GENSER-FORMAN INC.

TRIUMPH DISTRIBUTORS

Bulletin #174

SUBJECT: Revised Specifications
of Triumph TR-3

SUBJECT: Lighting Fuses
TR-3, Sedan &
Estate Wagon

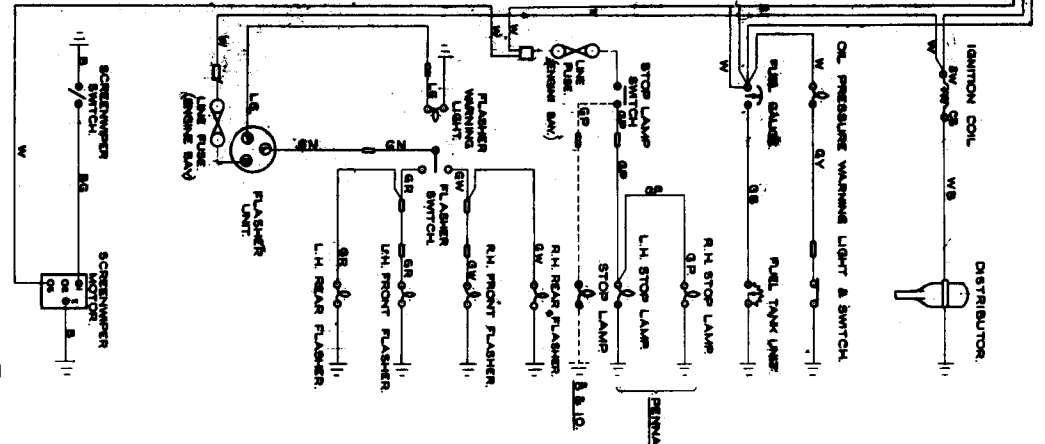
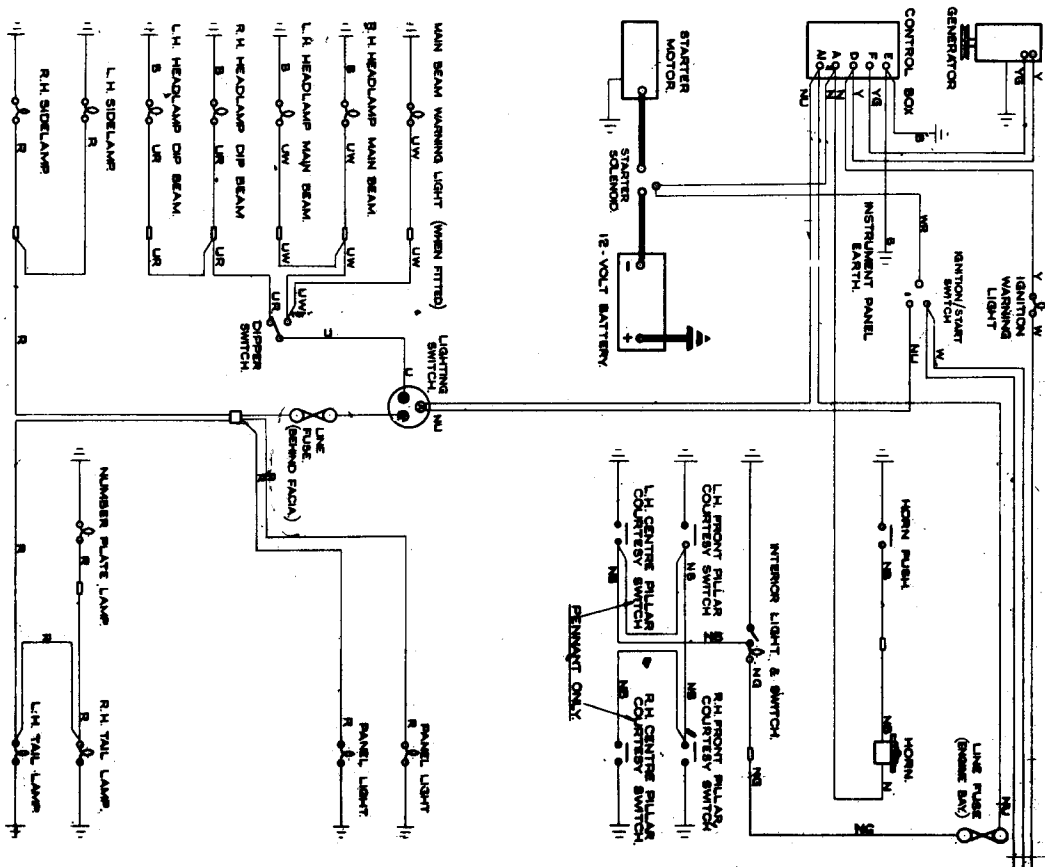
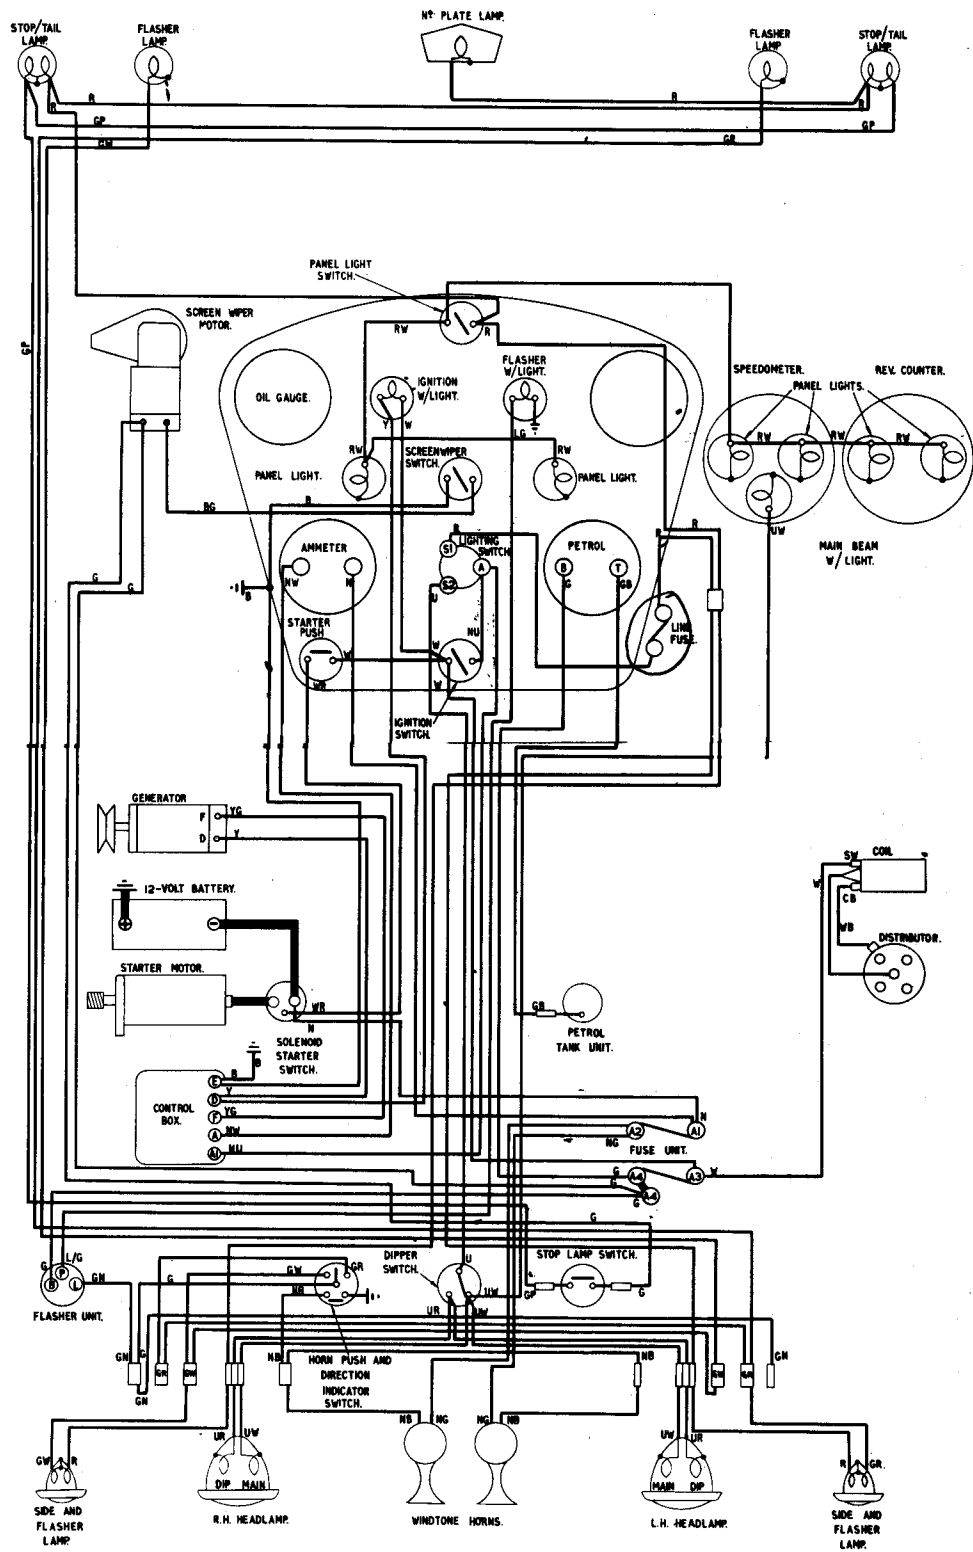
Advance information has just come through from the factory that line fuses are now being incorporated for the tail lights and stop lamp units together with the direction indicator lamps.

Three additional line fuses have been incorporated to protect the units on the Sedan and Estate Wagon. It has only been necessary to use one additional line fuse for the TR-3.

Attached are wiring diagrams showing the exact layout for your information.
